MSD INSTALLATION INSTRUCTIONS

Rotor and Rotor Base for MSD Crank Trigger Distributors with the Large Cap PN 8457

Figure 1 Updated and Discontinued Rotors and Bases.

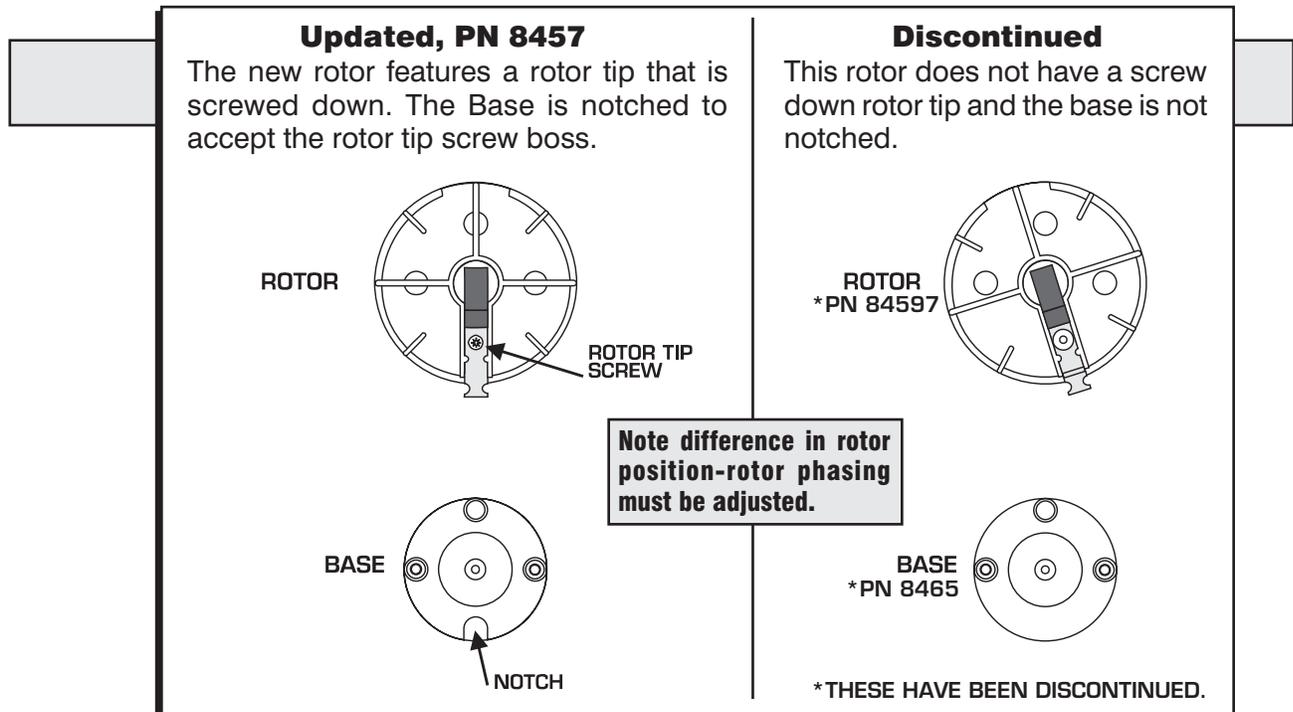
This Rotor and Base have been updated and **will not interchange** with the older style rotor or base. To differentiate between the two, see Figure 1. The PN 8457 Rotor and base replaces rotor, PN 84597, and base, PN 8465.

Note: The position of the new rotor on the base has also changed which means that the rotor phasing **must** be reset.
